STAFF REPORT
COMMUNITY DEVELOPMENT DEPARTMENT

HEARING DATE: 6/22/2021
 TO: Mayor & City Council
 FROM: Joe Dodson, Associate Planner
 208-884-5533
 SUBJECT: H-2021-0021
 Prevail North Subdivision

B. Preliminary Plat (dated: 5/7/2021)

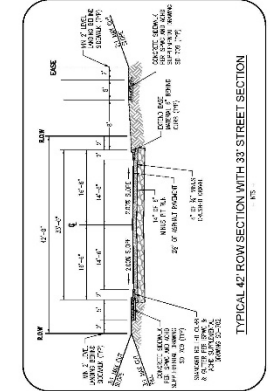
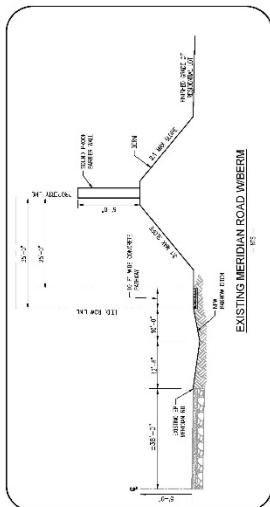
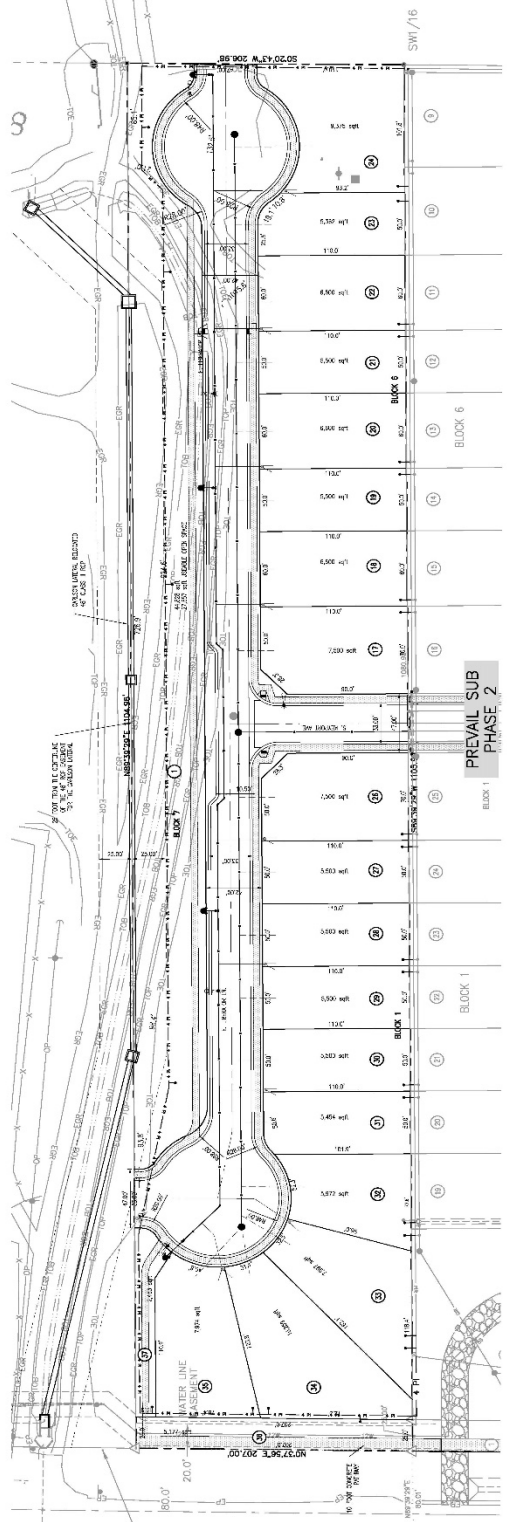
2. The preliminary plat included in Section VII.B, dated May 7, 2021, shall be revised as follows prior to submitting for Final Plat approval:
 - a. Revise the plat to show the landscape buffer common lot along Meridian Road to be at least 35 feet wide consistent with the required dimensional standards along an entryway corridor or apply for Alternative Compliance, per UDC 11-5B-5.

- b. Add a plat note stating that direct lot access to S. Meridian Road/SH 69 is prohibited.
 - c. Revise the plat to remove the stub street from the west cul-de-sac to the north property boundary, per the approved City Council waiver.

D. Color Landscape Plan – Prevail Subdivision Overall

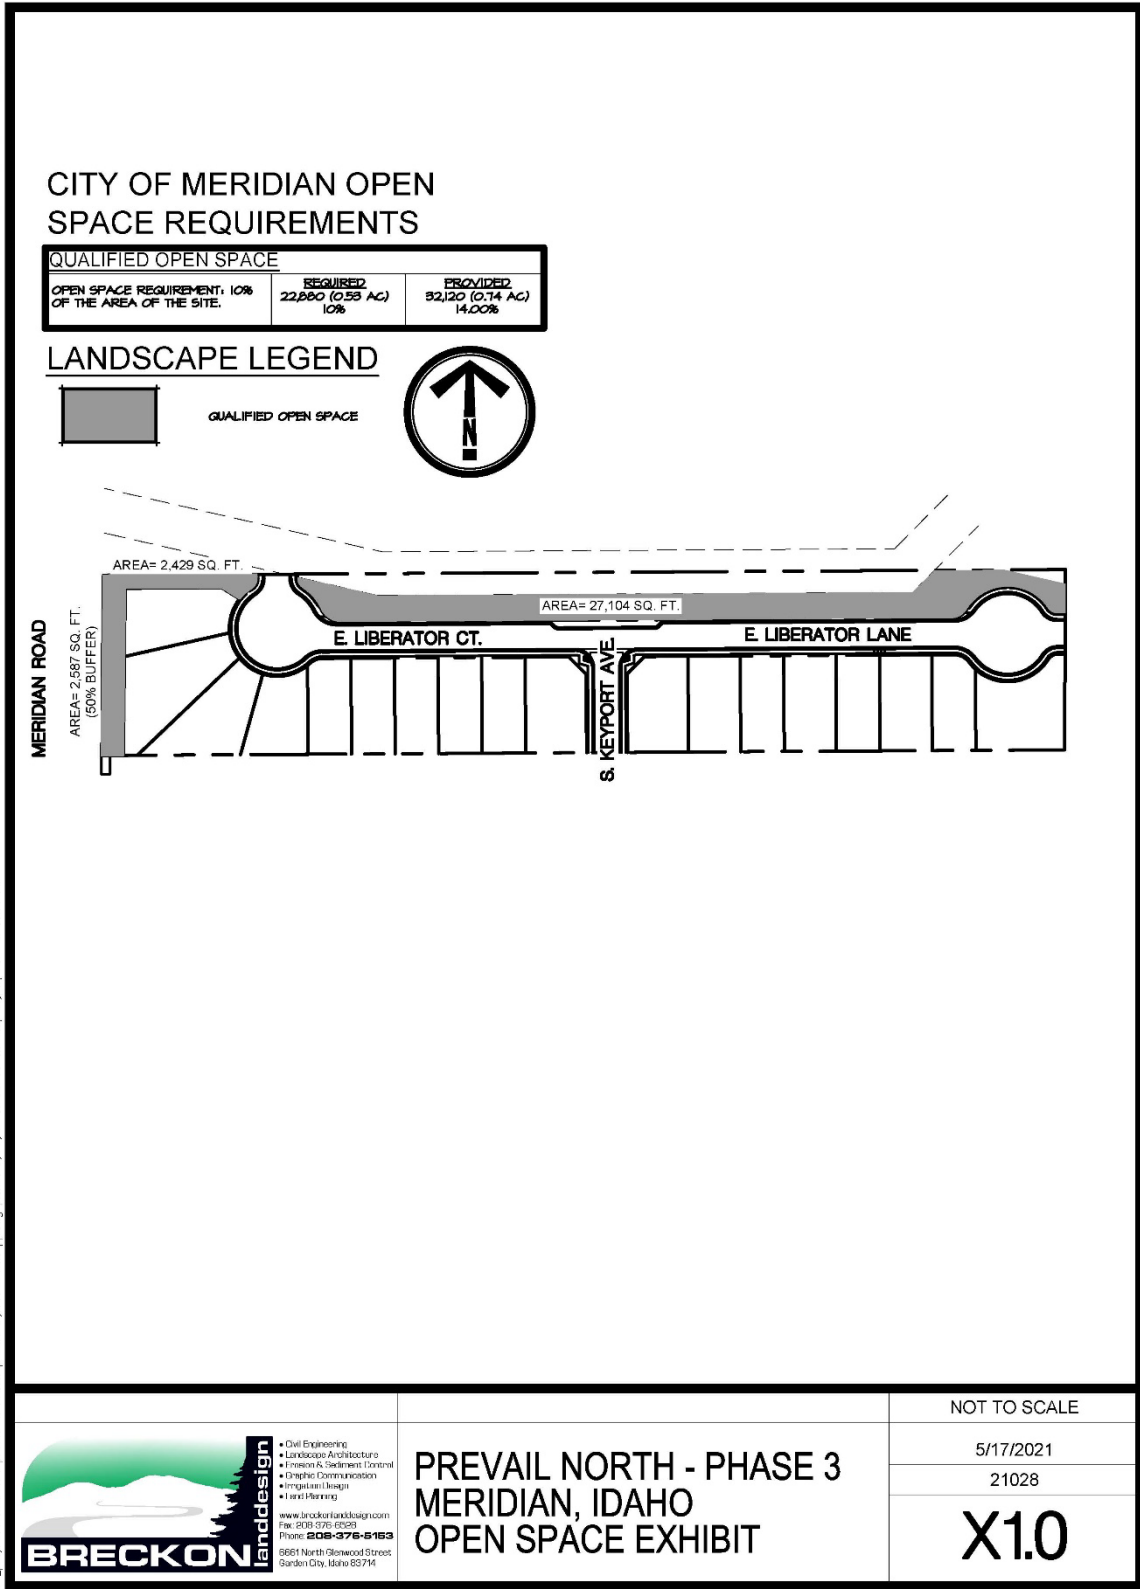
4. The landscape plan included in Section VII.C, dated ~~March~~ May 17, 2021, shall be revised as follows prior to submitting for Final Plat approval:

- a. Revise the plan to show the required landscape buffer along Meridian Road to be 35' instead of 25' or apply for Alternative Compliance, per UDC 11-5B-5.

- e. Any landscaping within the ITD right-of-way shall be landscaped in accord with UDC 11-3B-7C.5.
5. Future development shall be consistent with the minimum dimensional standards listed in UDC Table 11-2A-6 for the R-8 zoning district.

E. Open Space Exhibit — ~~NOT APPROVED~~ dated: 5/17/2021

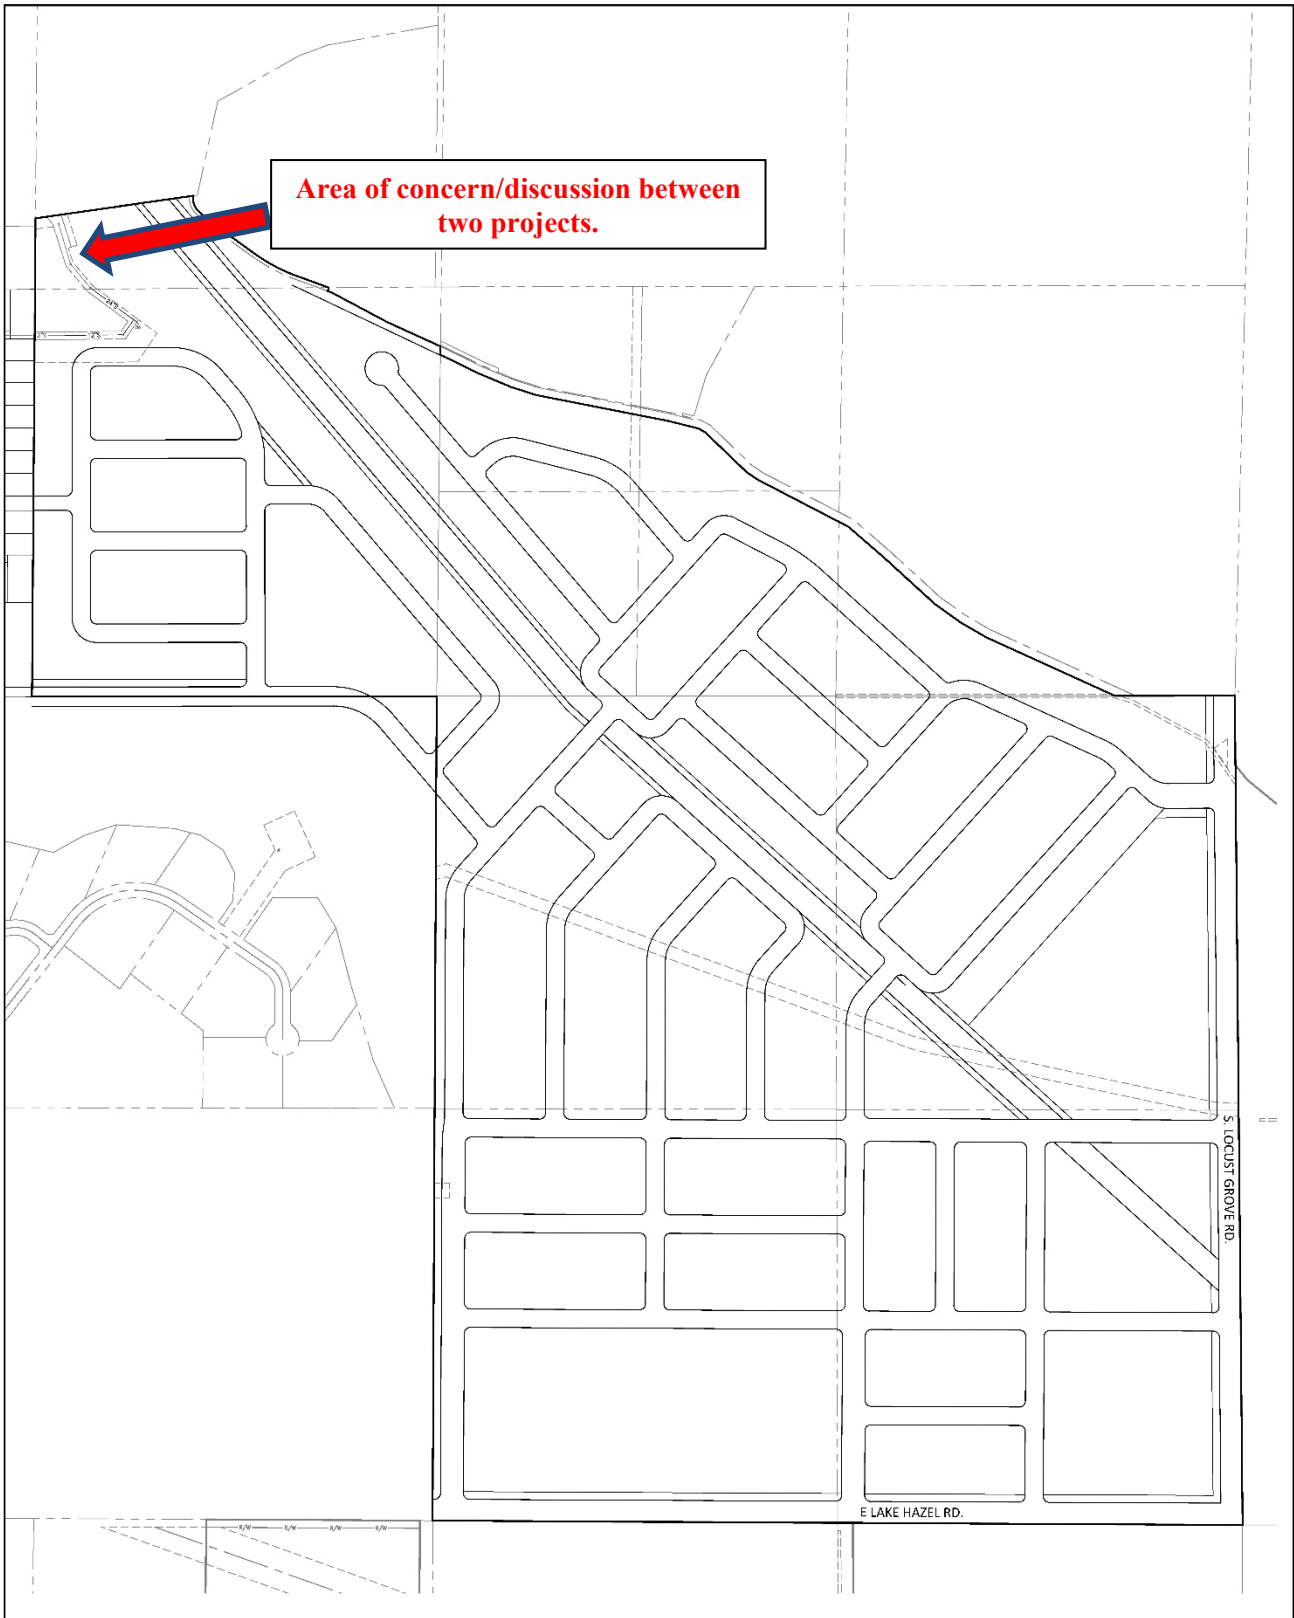
of the 5.25 plat area. However, not all of this area is qualifying after receiving the revised landscape plan that fences off a section of the open space lot that is impeded by the irrigation easement for the rerouted Carlson Lateral. After removing this area, the area of qualified open space is 32,120 square feet (0.74 acres) or 14% of the plat area. The proposed qualified open space still exceeds the minimum code requirements by approximately 10,000 square feet. Furthermore, this calculation uses the 25' landscape buffer width along Meridian Road instead of the required 35' width. Therefore, the actual amount of qualified open space should be slightly larger. The Applicant should correct the open space exhibit to reflect both the revised layout and the correct amount of qualified open space.
